UNITED STATES PATENT AND TRADEMARK OFFICE

APPLICATION NO.	FILING DATE	FIRST NAMED INVENTOR	ATTORNEY DOCKET NO.	CONFIRMATION NO.
10/717,240	11/18/2003	Mike MacArthur	ROB3108.03A	6893

Office Action Summary	Application No.	Applicant(s)	
	10/717,240	MACARTHUR, MIKE	
	Examiner	Art Unit	
	Sara Addisu	3722

DETAILED ACTION

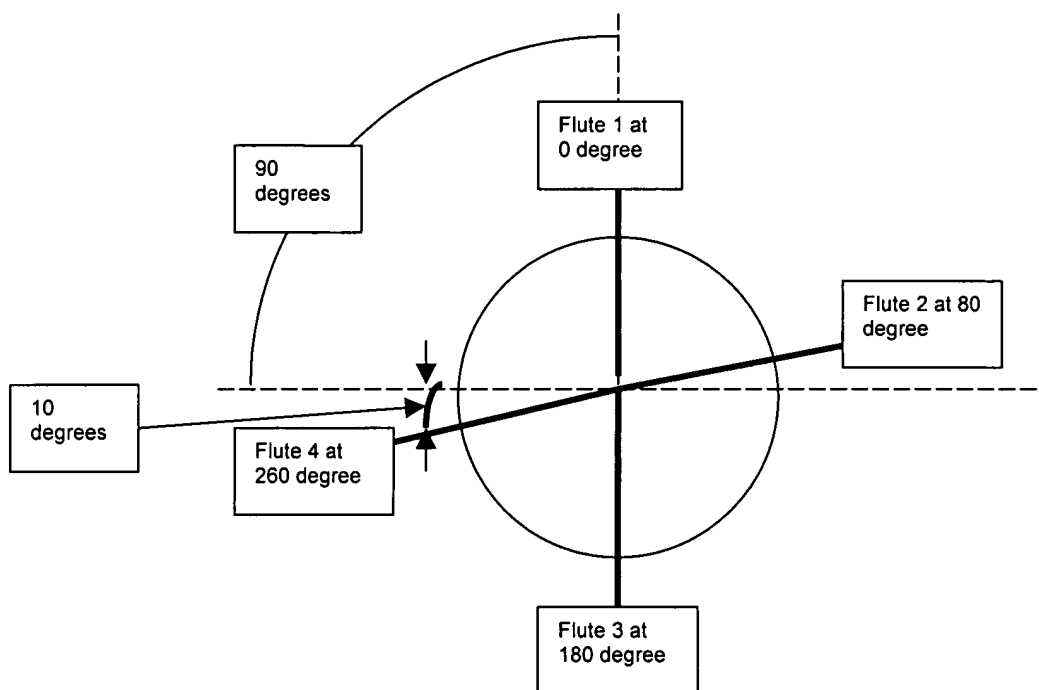
of paired flutes". Regarding claims 14 and 15, FLYNN ET AL. teaches flutes aligned directly from one another: four flutes located at 0, 80, 180 and 260 degrees (Page 2, paragraph 40). This configuration shows (see figure below) that the second-forth pair of flutes are off-set from the first-third pair of flutes by an amount of 10 degrees (which meets the limitation of between 1-10 degrees claimed in claims 14 and 15).
